Highgate Conservation Area Advisory Committee objection to HGY/2023/3350 for 488 Archway Road, N6 4NA.

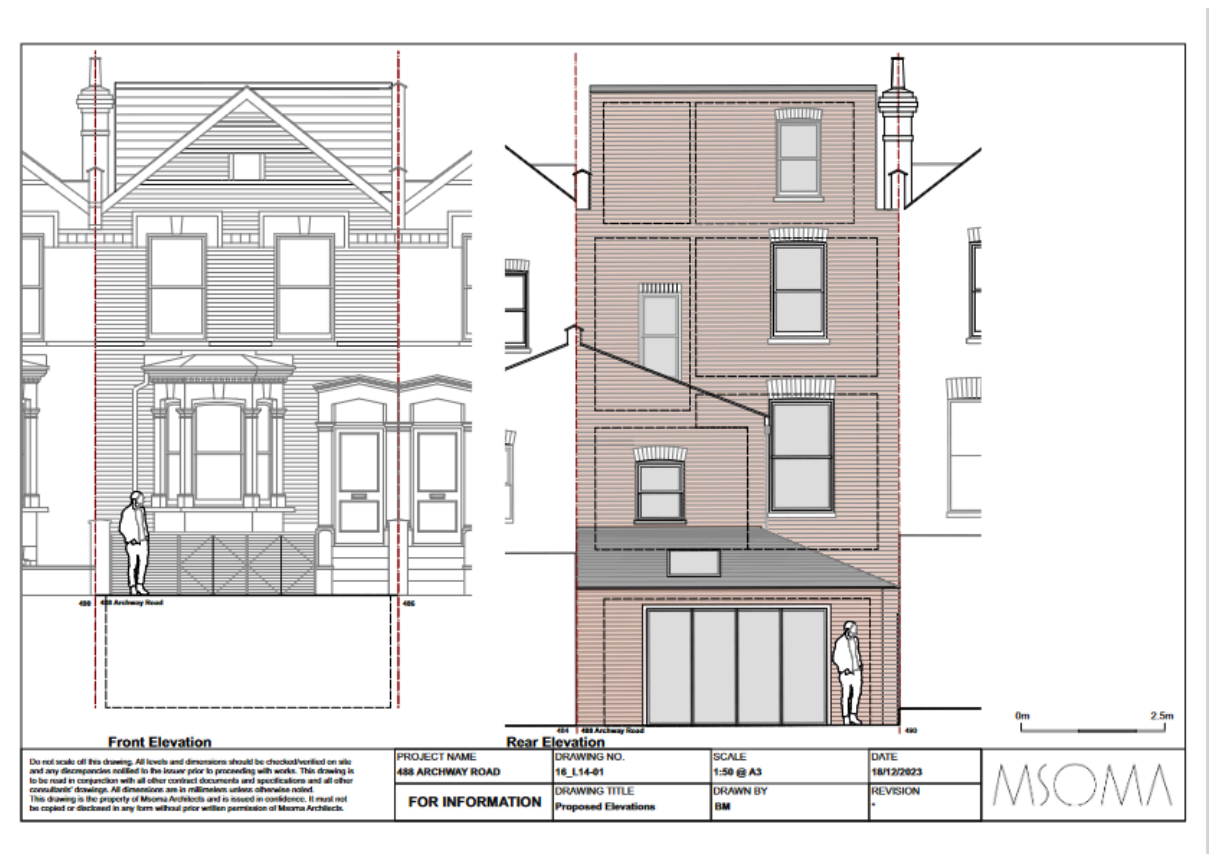
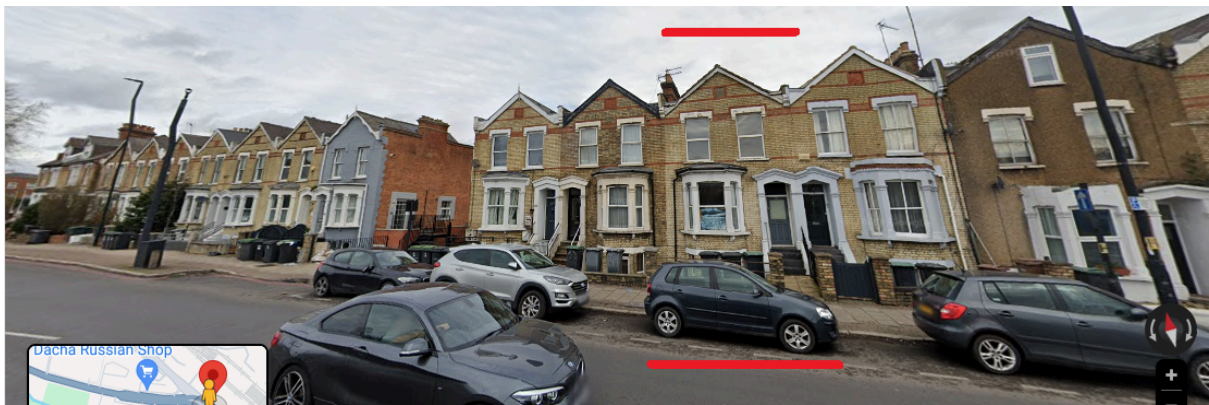
The proposed dormer is far too large, contrary to policy, and will be clearly visible from the public realm. It will destroy the consistency of a row of houses typical of the development pattern in Archway Road, thereby damaging the Highgate Conservation Area.

The proposed dormers extend from one side of the roof to the other at both front and back, and are not in any way subordinate to the host building.

This highly visible, over-dominant roof addition will interrupt a coherent Victorian streetscape, as described in Section 6.2 of the Highgate Conservation Area Character Appraisal and Management Plan (2013), being exactly the sort of “poor alteration” described in paragraph 6.9.1, “Negative Contributors”.
